SITE RECORD SHEET

PURCELL

Aconex Ref: OTH-PUR-TH-ZZ-SRS-A-0618	**Date:** 15/05/2024
Document Title: Albert Memorial – Omission of Works	**Revision:** -
Visit By: Jamie Coath, Andrew Bailey (Purcell), John Tomlin (LL), Steve Eccleshare (Bullen)	**Status: -** For Information
Attended: See below sections	**Attachments:** Photos embedded where applicable

Extract from Purcell drawing OTH-PUR-EE-ZZ-DWG-A-7144. Items to be omitted (circled in red) are 11.1.0a, 11.1.0b, 11.1.0c.

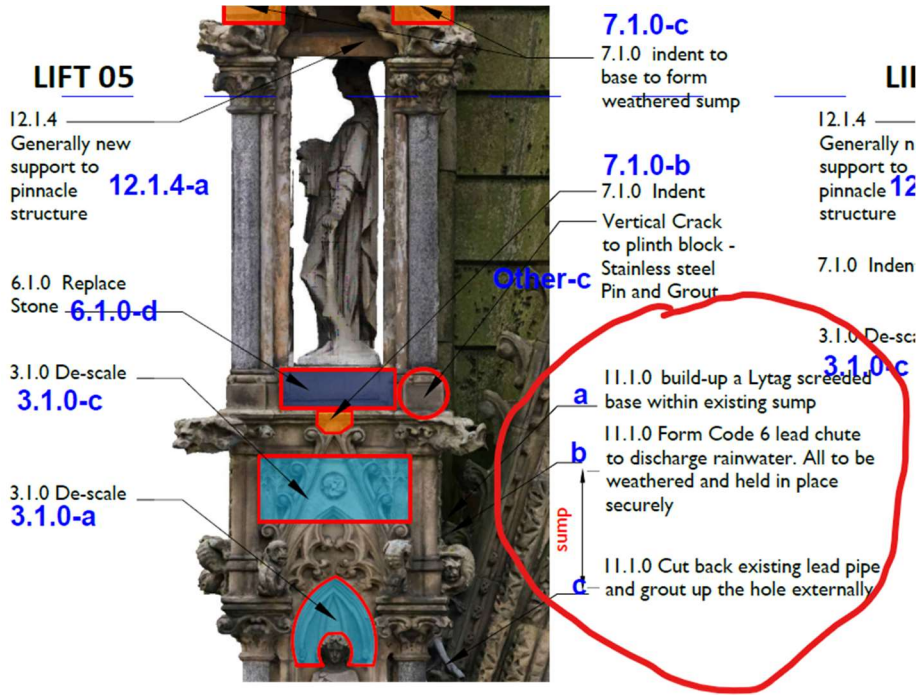
No	Item/Room	Comments	Action
		Following site review on 25.04.24, a series of originally proposed works are deemed no longer required.	
1.1	Albert Memorial – Sump Behind Corner Pinnacles	Following discussions on site, it was agreed that the proposed lead chute detail (to be formed onto a new Lytag screed base), which sits behind each of the corner pinnacles (4 nr. in total), is to be omitted. The existing sump and drainpipe arrangement is to be retained. Both sump and drainpipe have been cleared out and are now draining freely. Extract from Purcell drawing OTH-PUR-EE-ZZ-DWG-A-7143. Items to be omitted (circled in red) are 11.1.0a, 11.1.0b, 11.1.0c.
